Vital Images, Inc.
October 21, 2013
URGENT: MEDICAL DEVICE RECALL
(FIELD SAFETY NOTICE)
Vitreacore® Software

FSCA-identifier: 2134213-2013-00004

Type of action: Manufacturer's advice for workaround of a potential image orientation inaccuracy in certain 16-bit Secondary Capture snapshots

VPMC-13206A VitreaCore® Labeling Addendum

Fig-1: Prone Series

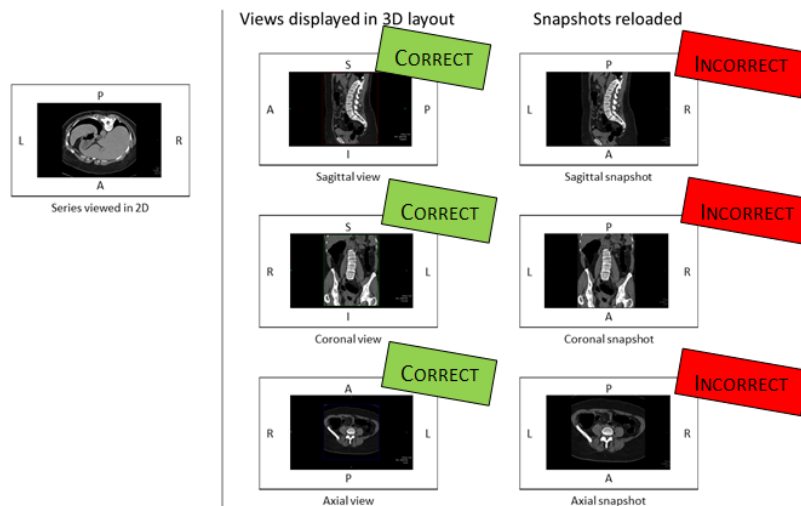
Scenario-1: Loading a prone series and taking a snapshot of the axial, coronal, or sagittal viewport:

Fig-2: Supine Series

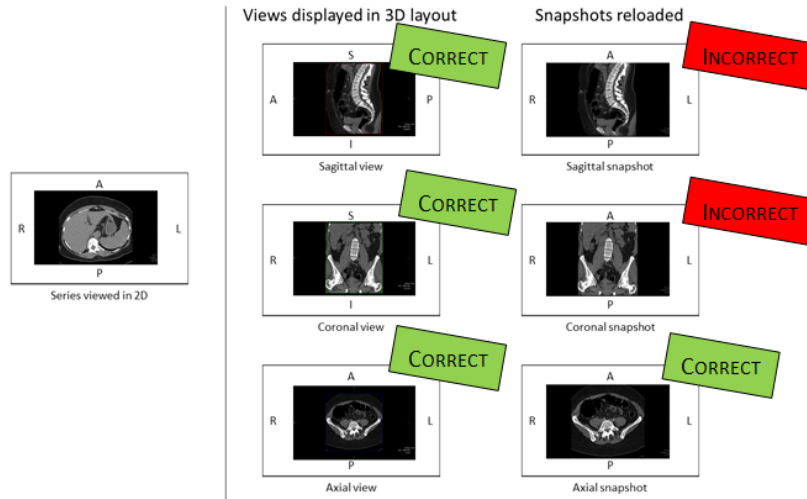
Scenario-2: Loading a supine series and taking a snapshot of the coronal or sagittal viewport:

Fig-3: Oblique Mode

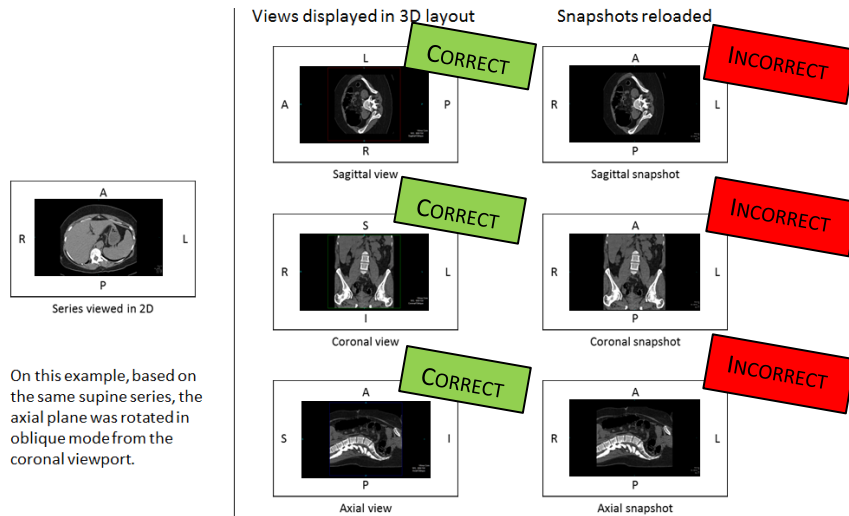
Scenario-3: Loading a supine series, switching the view to oblique, rotating the axial viewport such that the orientation markers change, and taking a snapshot:
